Memorandum

To: Wally Dubyk, CET (City of Ottawa, TES) Date: March 20, 2024
 Copy: Harrison Da Costa (ML Devco - Client) Project: 476577-01000
 From: Juan Lavin, P.Eng. / Jake Berube, P.Eng.
 Subject: **398-406 Roosevelt Avenue TIA**
Addendum #1: Revised Site Plan (2024-01-24)

APPENDIX A

Revised Site Plan (2024-01-24)

Figure 2: Revised Site Plan - January 2024

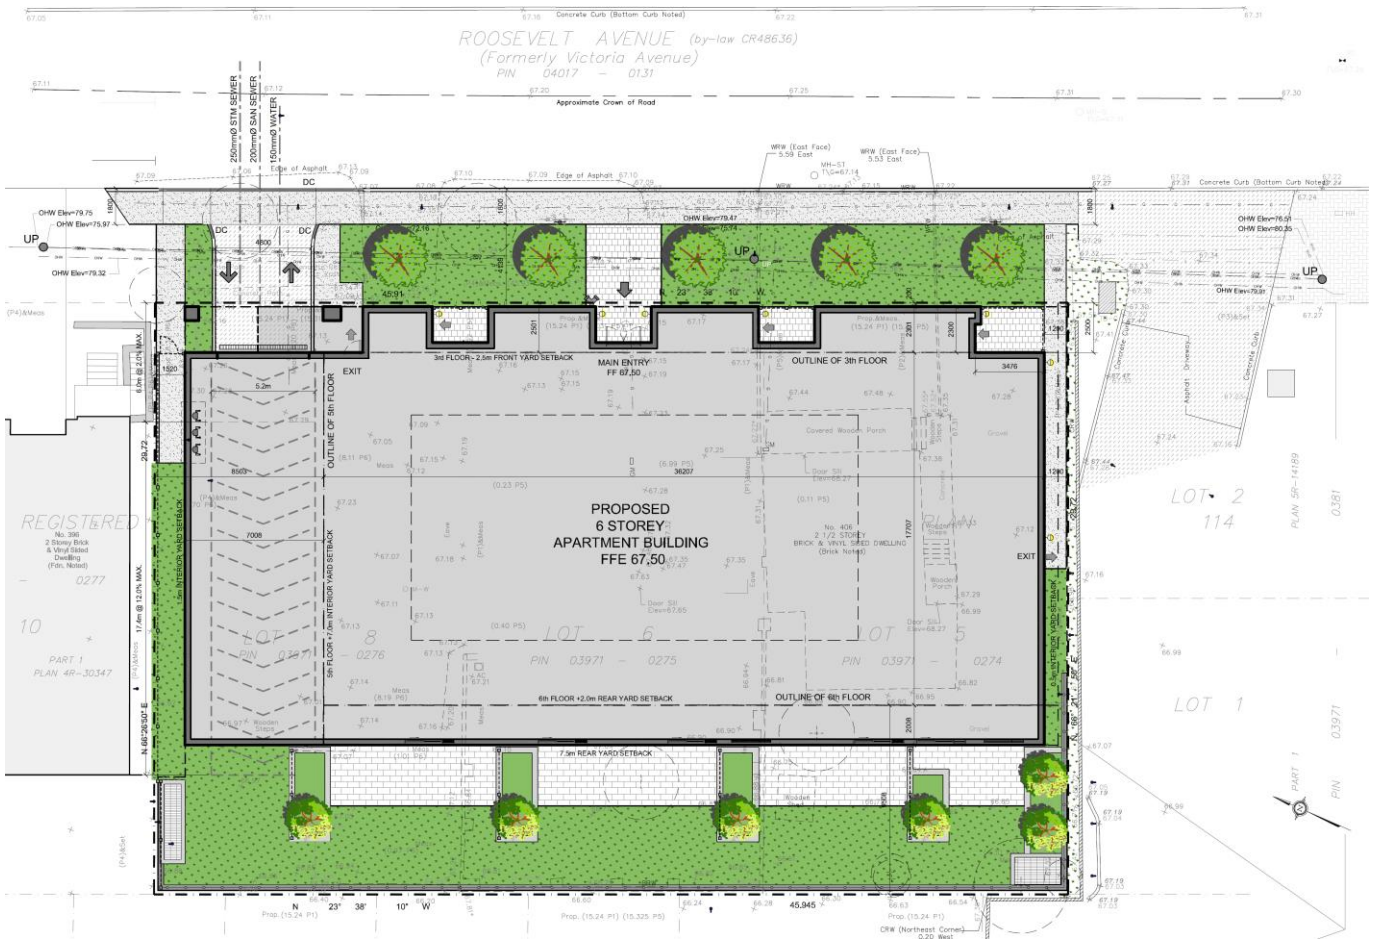
In comparison to the June 2022 site plan, the proposed site plan (January 24, 2024) includes an increase in residential apartment units, from 29 units to 62 units and a reduction in parking supply from 49 to 20 spaces. The increase in units has been accomplished by decreasing the unit floor area. The proposed Site Plan also proposes a parking ratio lower than the suggested Parking By-Law.

Overall, the site’s traffic circulation, location, quantity and dimensions for ramps and drive aisles have all remained consistent to the approved June 2022 Site Plan. Garbage pick-up is assumed at ground level on the street edge. There are no concerns or deviations noted from previously approved Site Plan, thus no further circulation analysis is required. **Table 1** below summarizes the new revised Site Plan statistics from January 2024 to the former approved Site Plan from June 2022.
